**City of Pompano Beach, Purchasing Division
1190 N.E. 3rd Avenue, Building C
Pompano Beach, Florida, 33060**

**ADDENDUM #2, BID H-08-12
WATER TREATMENT PLANT ELECTRICAL MASTER PLAN PHASE I IMPROVEMENTS**

City of Pompano Beach
Bid H-08-12
Water Treatment Plant Electrical Master Plan
Phase I Improvements

Addendum No. 2

A725 ROOF DRAIN SCUPPER FOR BUILT-UP AND
TYP SINGLE-PLY ROOFING

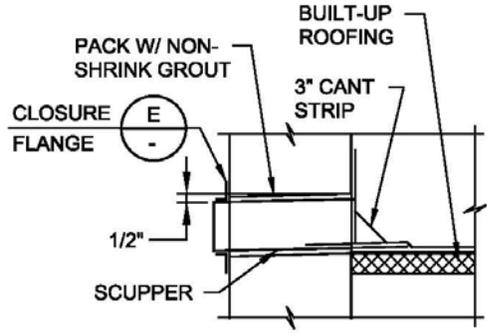
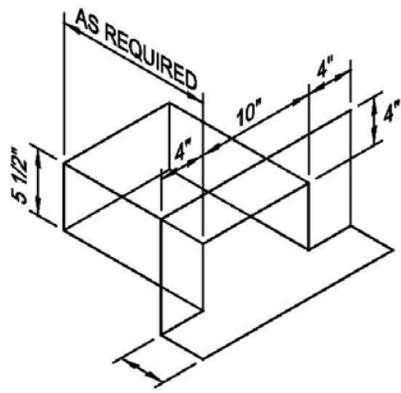
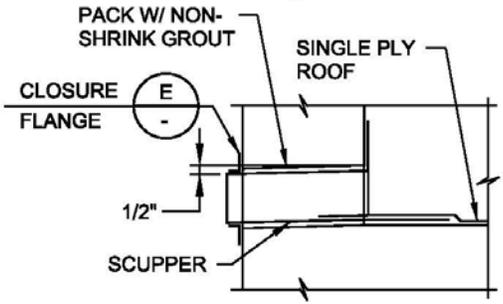
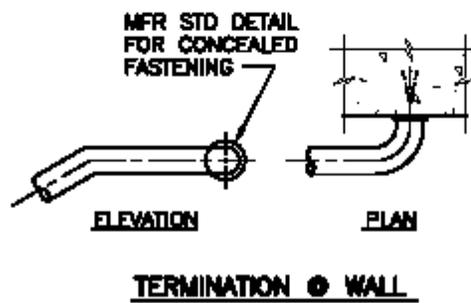
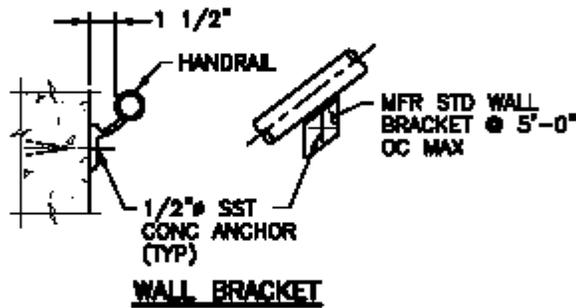
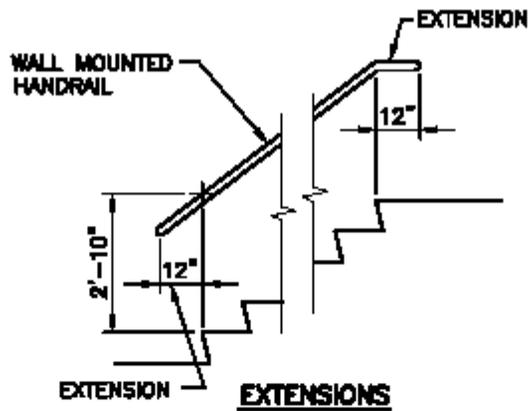
13. Drawing S-HSP-02 calls for a secondary overflow scupper but, drawing P-RP-01 says there is no need for one which is it? Yes, the secondary overflow scupper is required.

9. Drawing T-00-T3
 - a. Insert detail A 725 included with this addendum.

3. Drawing P-RP-01 delete the *General* note which says that secondary drainage is not necessary.
4. Drawing S-HSP-01
 - a. Key note 7 "remove existing galv stl guardrail and replace with new galv stl guardrail to match existing" shall apply to all handrails that are annotated by Key note 3 on C-SP-03.

- A. Submit shop drawings in accordance with section 01330
- B. Submit shop drawing with proposed modifications to existing roof, including:
 - 1. Proposed elevation of new primary and secondary scupper in accordance with pertinent building Codes.
 - 2. Drawings detailing the elevation of existing concrete deck, lightweight insulating concrete, supplemental insulation and roof membrane
 - 3. Submit statement certifying compliance with requirements and showing coordination with existing roof installer so as not to void warranty.

- A. Establish elevations of new scuppers so as to comply with building codes and to avoid a low spot where existing roof drain is being removed.
- B. Repair alterations, attachments, new openings, and other disturbances in existing roof for new construction features in manner that will satisfy original manufacturer's warranty.
- C. Remove and replace mineral cap sheet as required to remove existing roof drain.
- D. Patch insulation as required due to removal of roof drain. Slope new insulation as required to drain to new scupper.
- E. Install new roofing and flashing as required to match existing roofing, which is to remain.
- F. Complete new roofing in manner that maintains a watertight installation.
- G. Repair areas of existing roof damaged by new work.
- H. Recoat minor damage with surfacing to match existing.
- I. Conduct leakage test to prove integrity of new roof.
